Site Plan Review Committee (SPRC)
Staff Report for
3200 Wilson Blvd. – Bingham Center (Silver Diner Site)

**Item 1. Bingham Center (SPLN21-00009)
3200 Wilson Blvd.**

SUMMARY: The applicant, TCS Realty, proposes redeveloping the site with two buildings, a hotel, and a multifamily residential building. The two buildings total a 5.09 FAR (approximately 412,353 sq. ft. and would contain approximately 16,000 sqft. of ground floor retail.

ACZO §9.2.5 Map 1, Max Height Limit and Step Backs

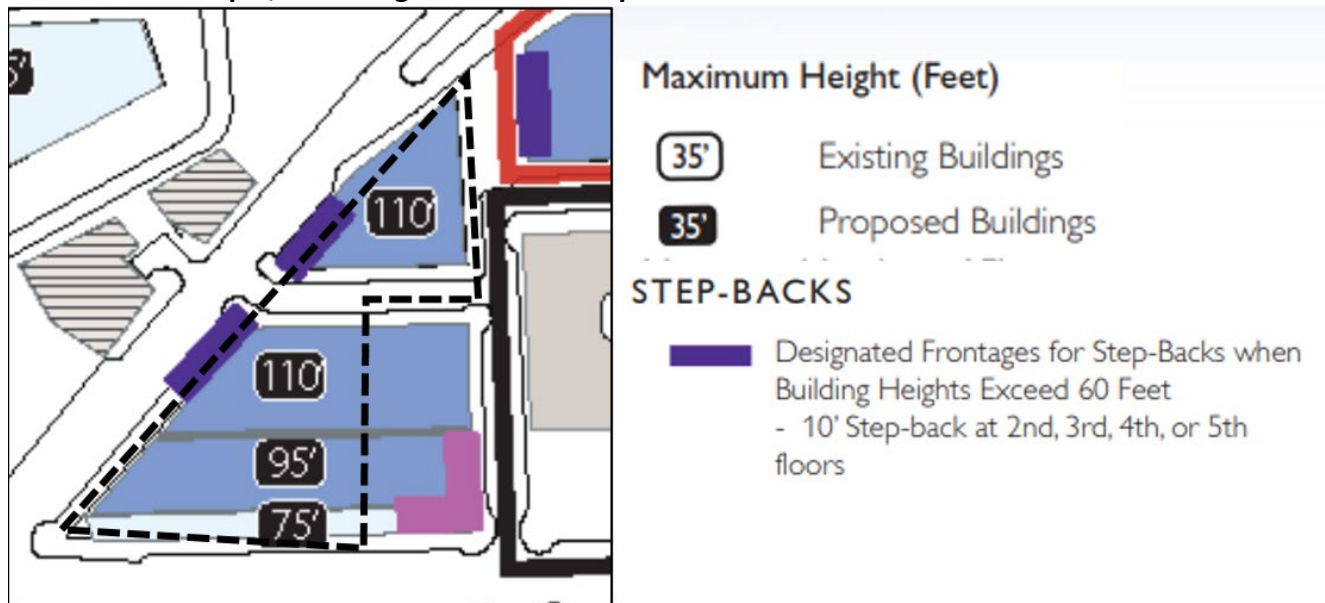
Density / Building Height and Step-backs: As provided in the Sector Plan, the County Board may approve optional increases in density above 3.0 FAR pursuant to §15.5 of the Zoning Ordinance by approving additional floors subject to the Maximum Height (feet) on the Maximum Heights Limits and Step-backs Map (§9.2.5, Map 1). The applicant is proposing a total of 5.09 FAR, an additional 2.09 FAR above the base density of 3.0 FAR. A portion of the additional density will be achieved through compliance with the Green Building Incentive Policy. On Map 1, below, you can see the step-backs that are called for from 10th Street North toward the northern portion of the block. The applicant’s proposal is complying with the building taper from 75’ to 95’ to a maximum of 110’.

Renderings Pointing to the Proposed Step-backs

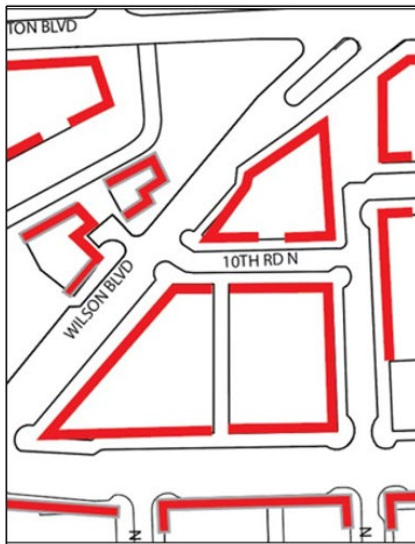
The Sector Plan calls for two step-backs along Wilson Blvd. where the new 10th Road North meets Wilson (identified as purple bars on §9.2.5 Map 1). The purpose of the step-backs is to contextually appropriate to the existing buildings and ensure a pedestrian scale environment. The applicant’s proposal does not include the step-back as envisioned in the sector plan. Instead, they are proposing a triangular carve out on the hotel building at the second floor and a reduced step-back at the 6th floor along the full Wilson frontage on the residential building (see images below).

Sector Plan Build-to-Lines and Hotel Ground Floor Plan

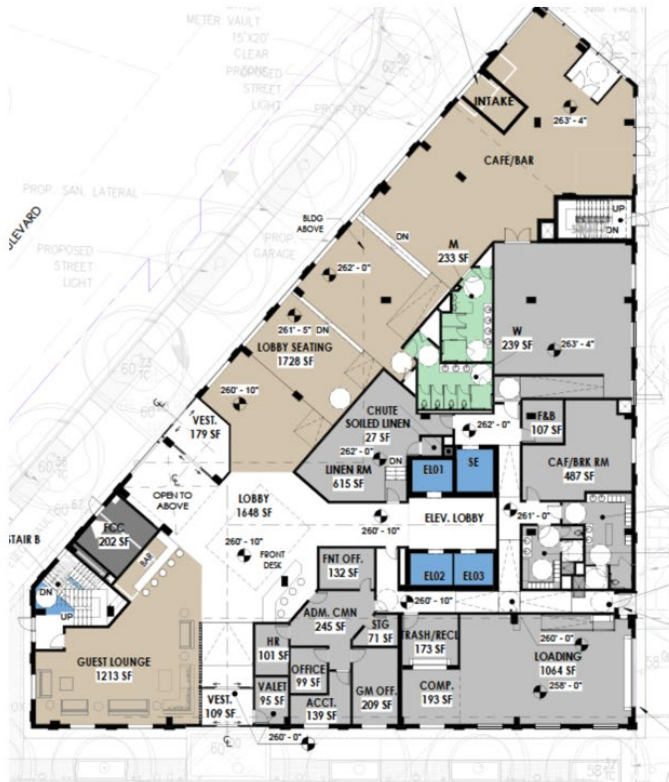
For the hotel building, the Sector Plan envisions that the entrance for loading will be located off of the new 10th Road N. The applicant is proposing a deviation from this that would locate the loading area from N. Irving St. The Sector Plan also identifies the N. Irving Street frontage to have retail, retail equivalent, food, entertainment, or service uses as the ground floor uses. In the ground floor plan below, you can see that the applicant is proposing instead to have loading and other back-of-house uses along N. Irving St.
